D.R. HORTON - GRANDVIEW RESERVE SANITARY SEWER LIFT STATION DESIGN & PERMITTING SERVICES
 EL PASO COUNTY PEYTON, CO

EROSION AND GRADING CONTROL PLANS
 COVER SHEET

Grandview Lift Station - Landscaping - Submittal 1 Comment Response

SHEET
 C-109

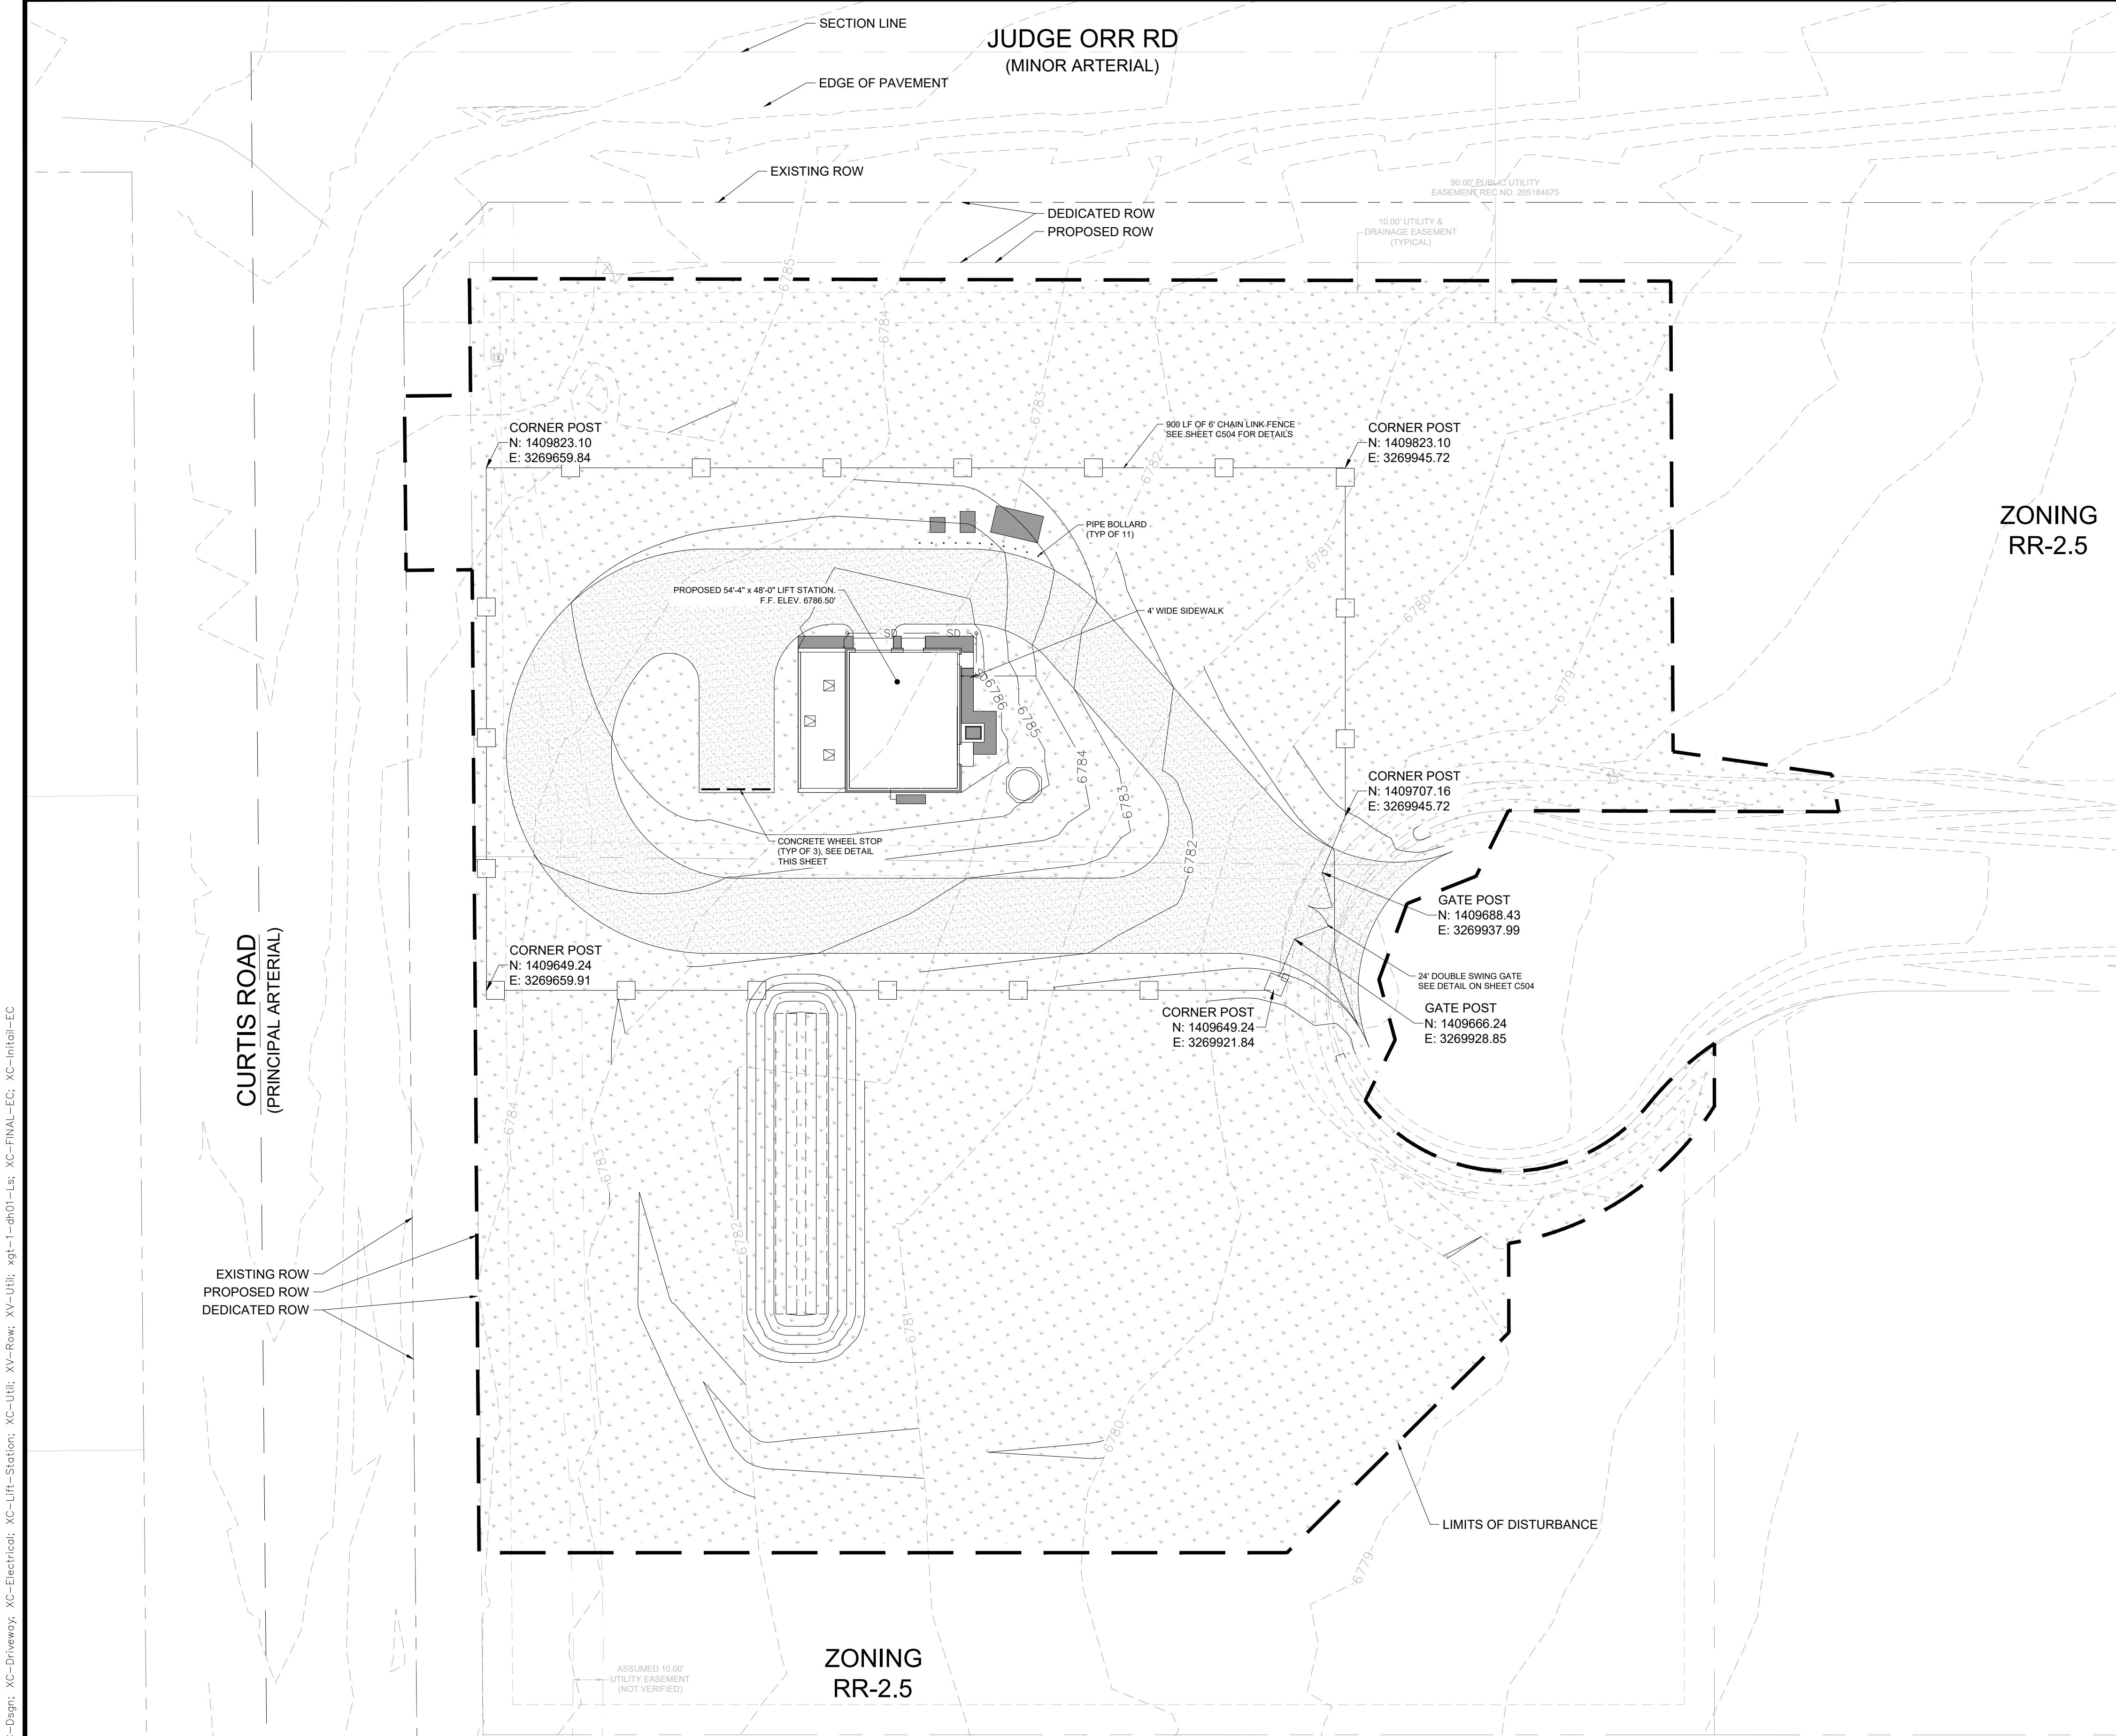
Page Label	Comments	Author	Date	HR Green Response
C109	File Number: PPR2421	ashmathy	7/29/2024	Added
C109	<p>Please include:</p> <ul style="list-style-type: none"> - Show an image the property as a whole not just a zoomed in portion -The existing zoning of the subject property and the existing zoning of surrounding properties. - Title "Substitute Landscape Plan" -Table depicting what is provided vs required -Sight distance triangles and any plantings, signs, walls, structures, or other visual obstructions within the triangles where applicable. -The location, type, size, and quantity of major existing plant materials meeting the plant type requirements, including all vegetated ground cover areas, shrubs, and trees, with information as to which materials are proposed to be removed and which shall be retained or relocated. -All proposed ground cover areas shall be identified, including the types and amounts of living plant materials to be used and the size and depth of non-living materials. The manner in which any lawn areas are to be established (for example, by sodding or seeding) shall be indicated. <p>The landscape treatment of all adjacent right-of-way areas, as well as the owner/ developer's property, shall be identified.</p> <p>Location of:</p> <ul style="list-style-type: none"> -ROW (depict ROW dedication too) -Easements - surrounding zoning districts 	ashmathy	7/30/2024	<ul style="list-style-type: none"> - Vicinity map added to landscape sheet. Viewport adjusted. - Labels added. - Title revised. - Table added. - Not applicable. - No major existing vegetation. - Existing ROW's to be preserved. Any disturbed areas to to be revegetated and returned to original condition. - ROW shown and labeled. - Easements shown and labeled. - Labels added.
